Value Engineering Study Report

Terrebonne Basin Barrier Shoreline Restoration Multipurpose Operation of Houma Navigation Lock Convey Atchafalaya River Water to Northern Terrebonne Marshes

CEMVN-VE-09-04

June 2009

EXISTING DESIGN WITH 200'x1200' LOCK

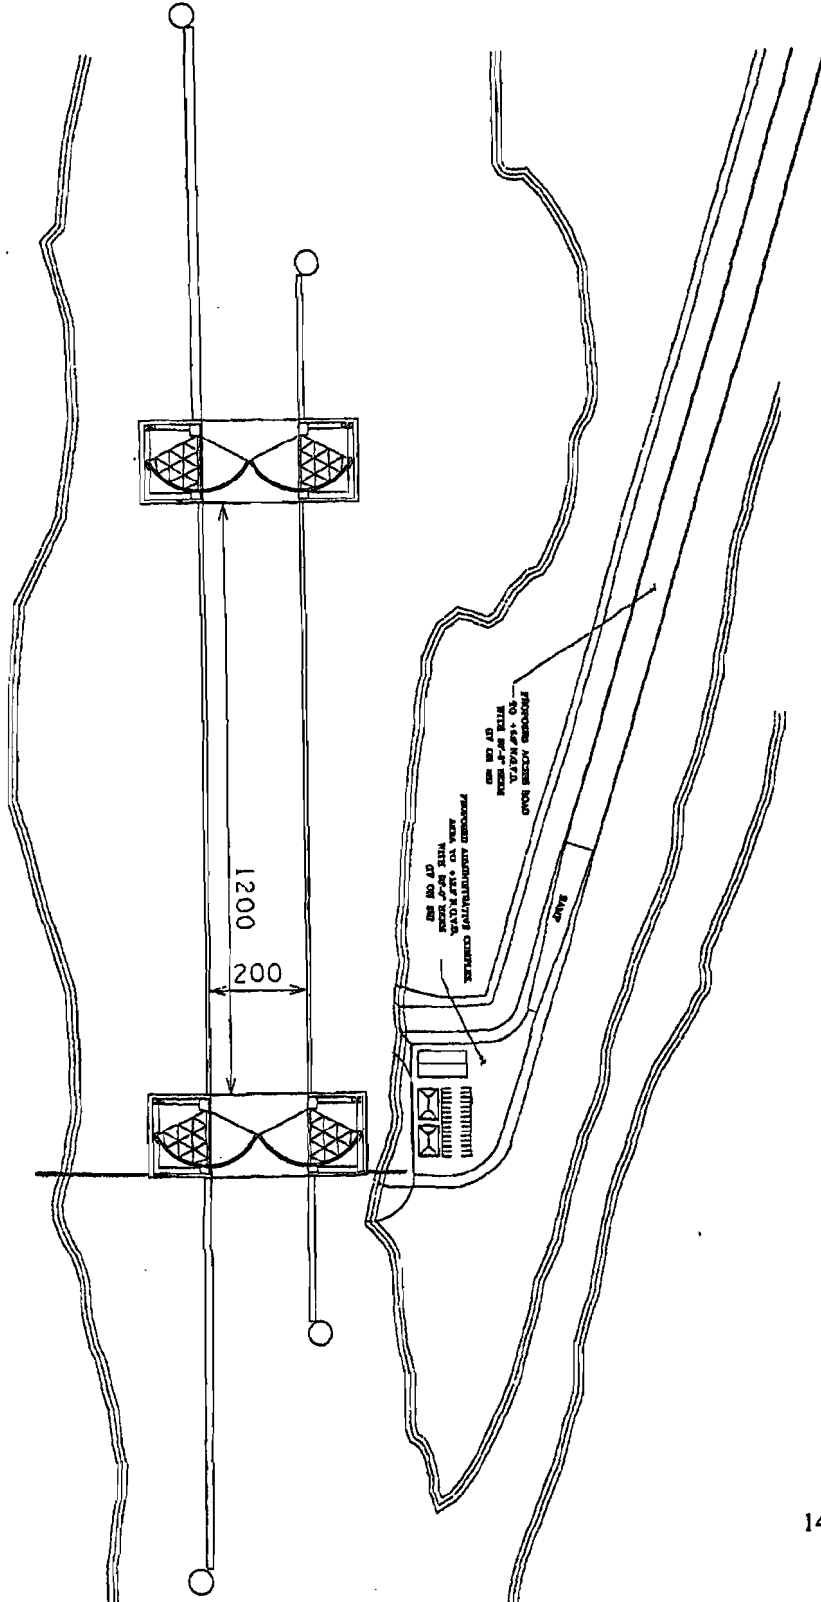
Although this type of gate may take longer to open and close, it is not believed that any significant salt water intrusion volume would occur, especially if operation (to pass a rig) is coordinated with tide change.

Given the unique large size of these gates and the probable known and unknown problems to be encountered, the further detailed evaluation of alternative gate types appears to be warranted.

PROPOSED DESIGN WITH 200' HINGED BARGE GATE AND 84'x750' LOCK

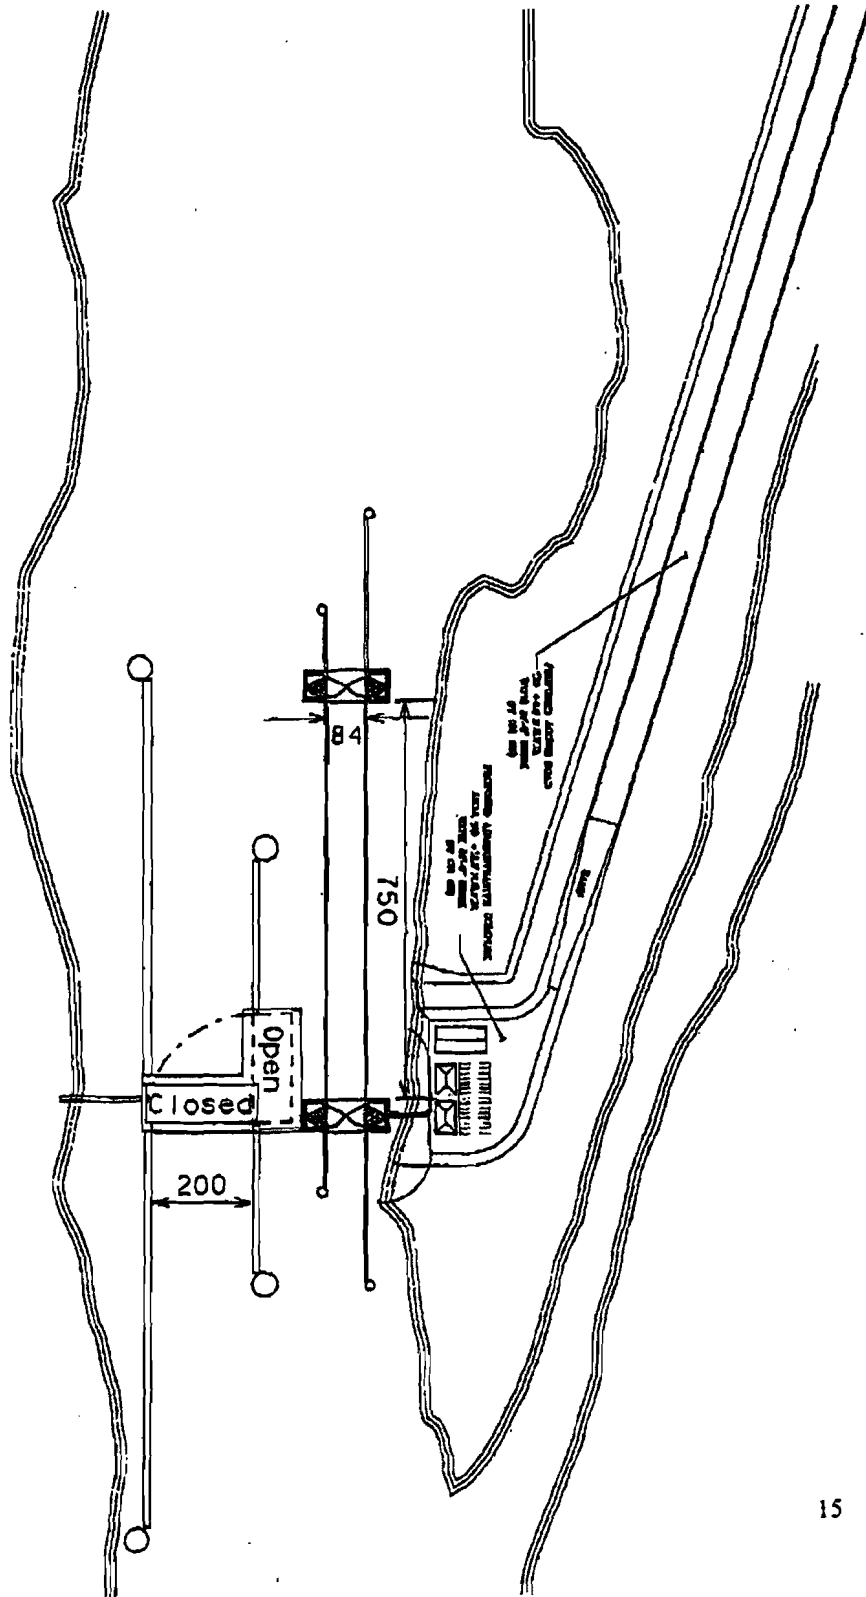
The justification for this proposal is the cost reduction of a smaller lock and swing gate for flood control when compared with large sector gates. Smaller swing gates have been built with success. The theoretical reduction of operating forces should also decrease the time between maintenance periods which will further reduce costs. Balanced gates should function efficiently.

Separation of the 200-foot gate from the lock would appear to allow depth, width and length reduction of the lock given the apparent traffic consisting of primarily crew and fishing boats. Sector gates have been the preferred choice for smaller applications. It should be noted, however, that there is a geometric divergence in the total structure size of a sector gate relative to other "bar-type" or "door-type" alternatives. There are significant concerns with possible (unknown) operational problems of sector gates of this size. Siltation problems, alignment of drive systems, and other currently unforeseen difficulties appear to warrant concern. Maintenance, particularly that of the removal of such large gates, also appears to be an issue.

Conversely, there are certain concerns with the proposed change. It appears that such problems could be solved through further engineering. Reverse operating head criteria, currently shown at 5.0 feet for the lock structure, appears to be overly conservative for the gate portion of the system since some waiting on more favorable tide conditions can be done. A reverse operating head of about 2.5 feet would appear justified.

PROPOSED DESIGN WITH BALANCED SWING GATE

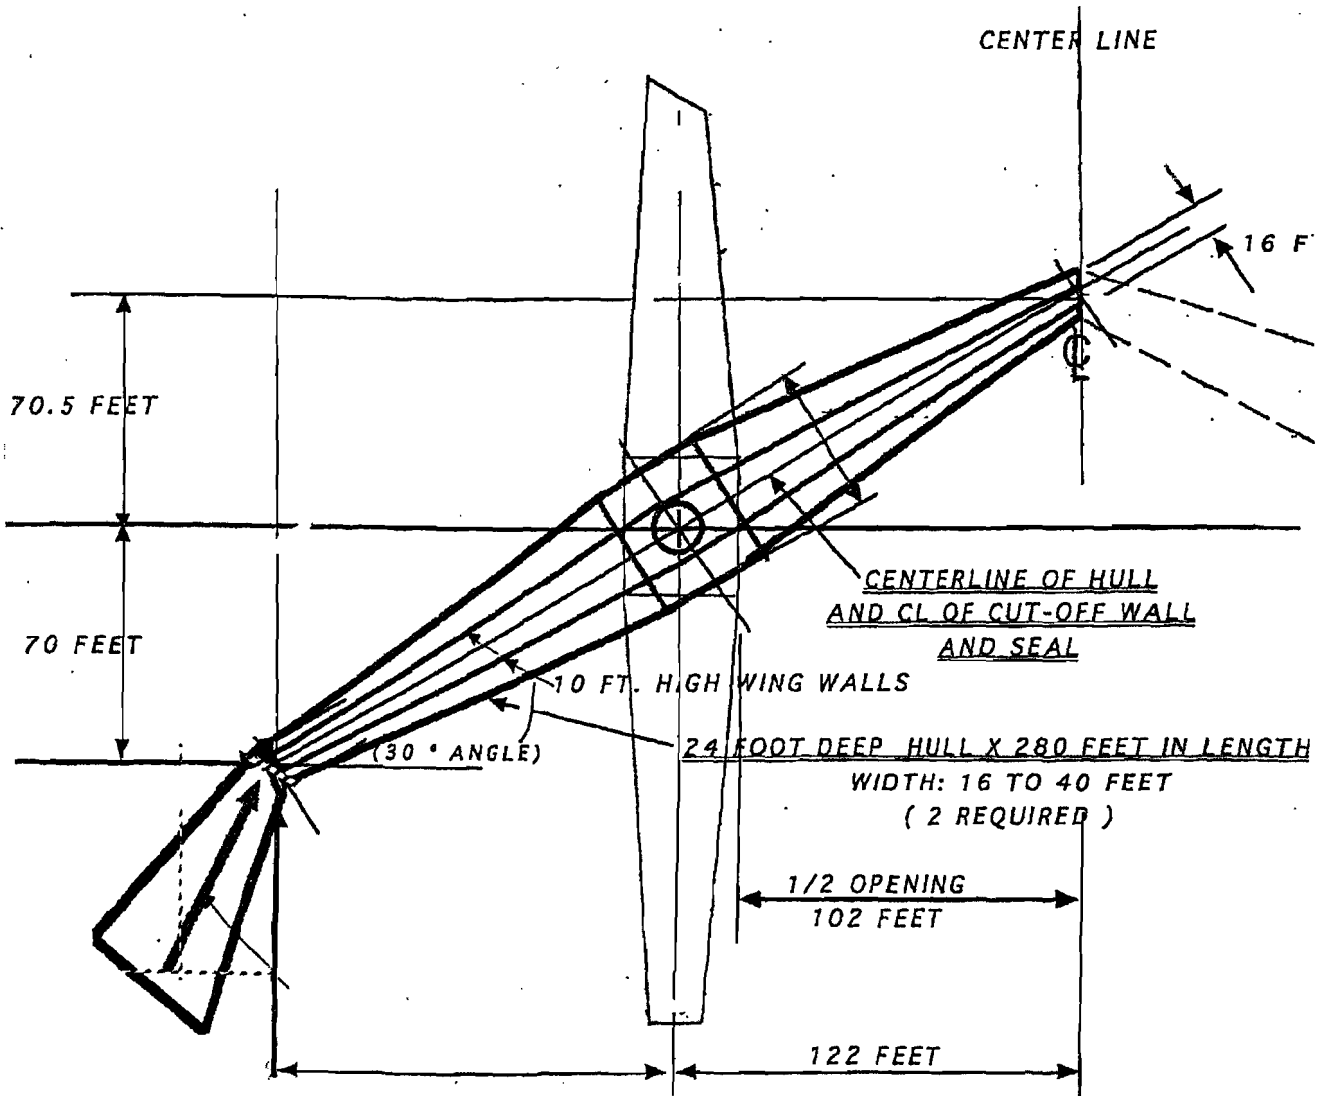
Given the unique large size of these gates and the probable known and unknown problems to be encountered, the further detailed evaluation of alternative gate types appears to be warranted.

EXISTING DESIGN FOR COMPANY CANAL

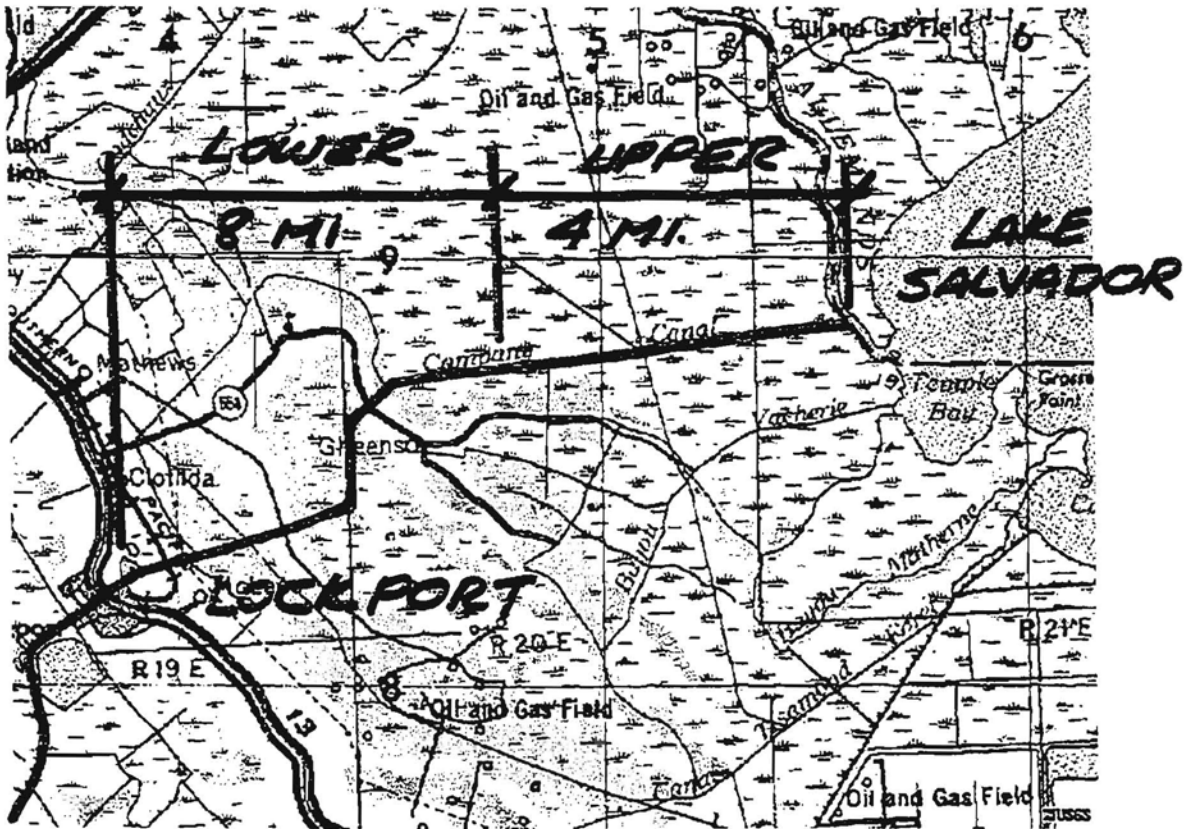
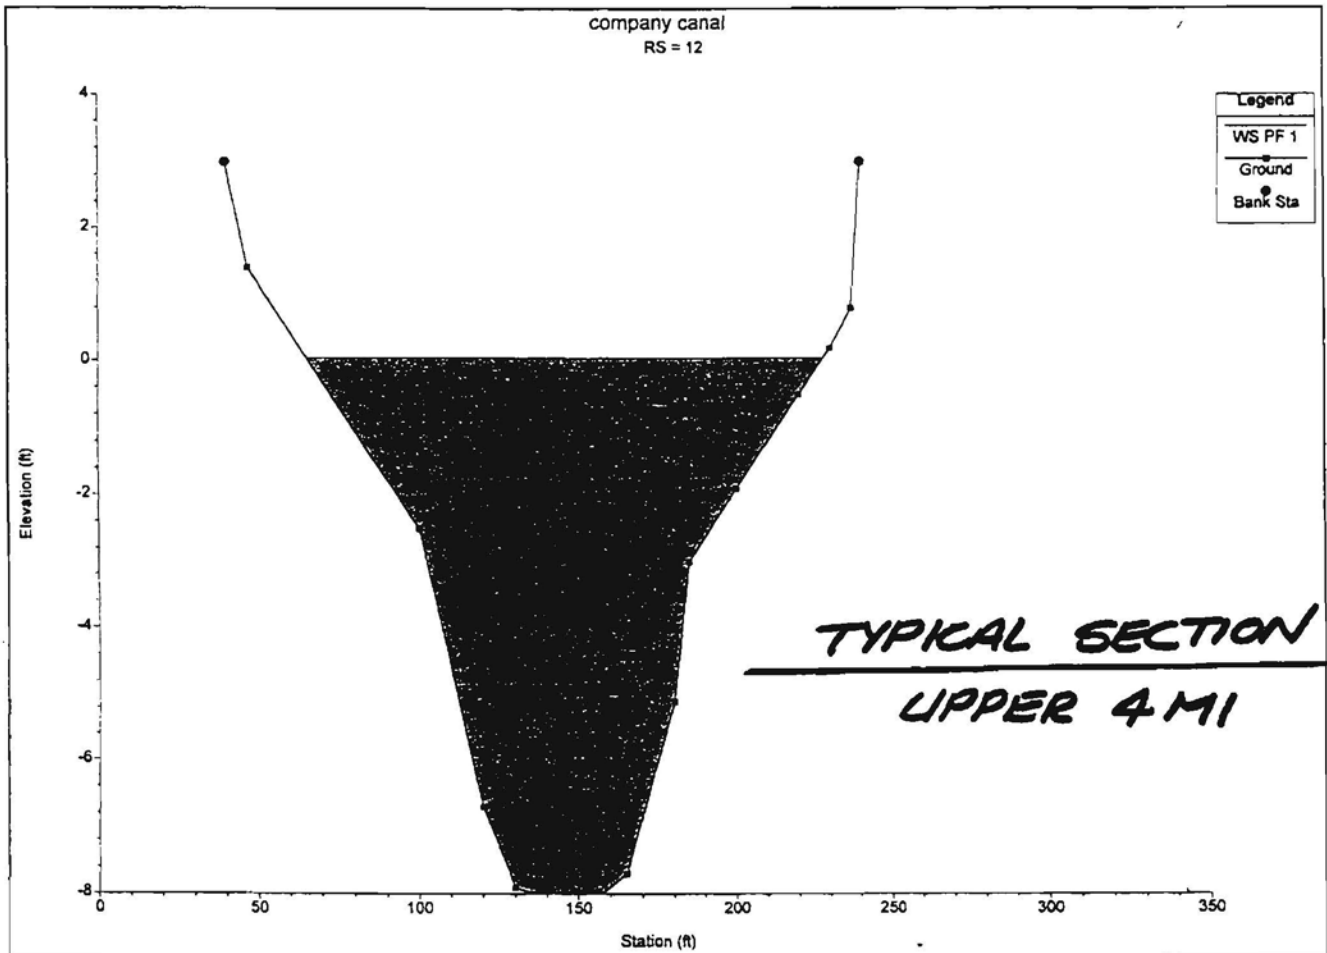
In contrast, redirecting 800 CFS from Lake Salvador only requires improving 12 miles of an existing canal that cuts through undeveloped land. Access to the existing canal is simple and the dredged material can be pumped to beneficial use areas. Construction is both quicker and easier and benefits will be realized sooner. Flow re-directed from the Davis Pond Diversion Project may be non-beneficial if, and when the full 10,000 CFS is needed. During most diversion events, however, less than 10,000 CFS diversion is anticipated. The additional 800 CFS could likely be 'made-up' just by a slight flow increase without adverse effect. There may likely be an opportunity to create new marsh with the disposal from dredging Company Canal. It is estimated that over 400 acres of nearby open water could be filled to immediately create/restore marsh from the 68 acres of cut.

The utilization of river flow supplied by the Davis Pond Diversion and conveyed via Company Canal appears to be a far more cost-effective means of achieving project goals.
